ADDENDUM NO. 1 TO THE SPECIFICATIONS AND CONTRACT DOCUMENTS

City Project No. WTR25002

CROWN RD. TRANSMISSION MAIN

November 3, 2025

SHEET: C-3 OF: 6

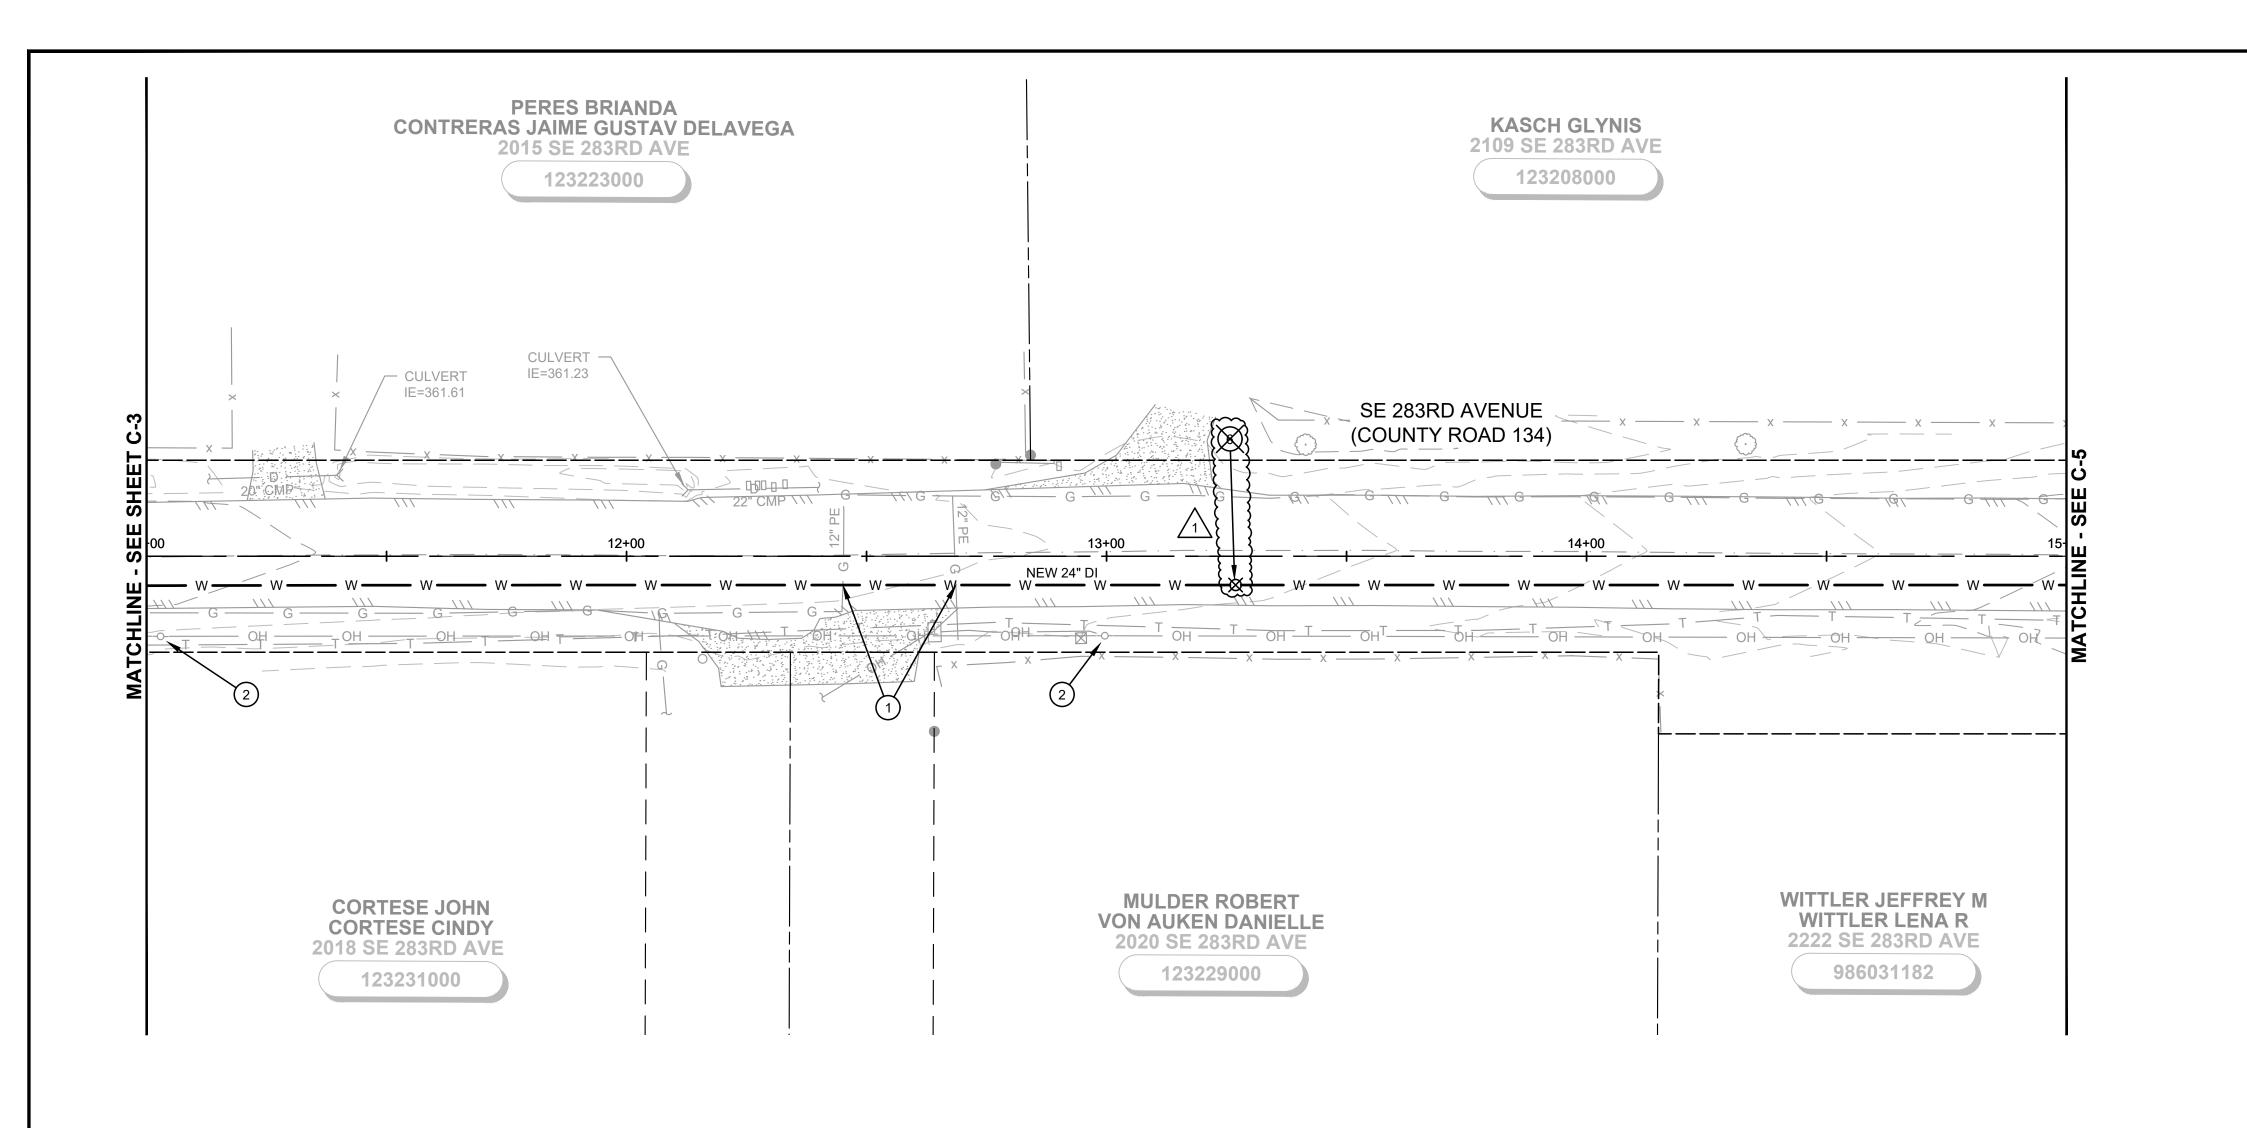
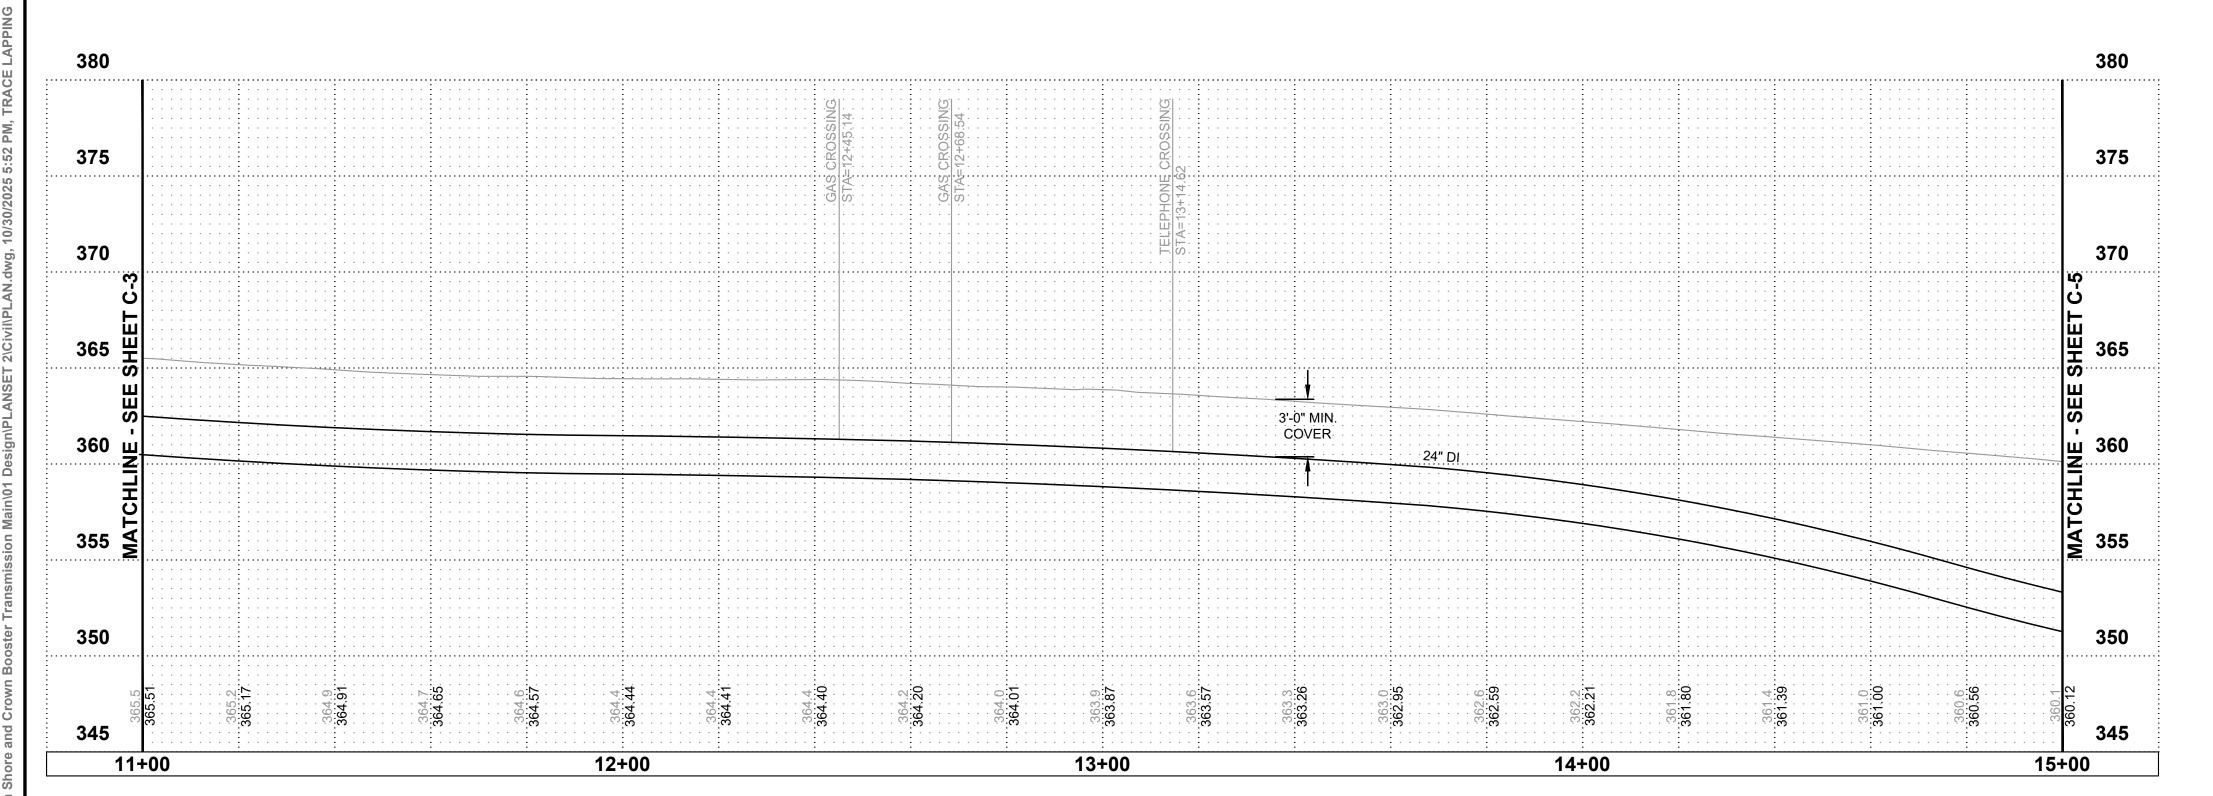
SHEET C-3

On plan and profile, ADD LOCATE STATION at STA=10+42.87
On profile, ADD HYDRANT ASSEMBLY24" BUTTERFLY VALVE call out at STA=10+50.00
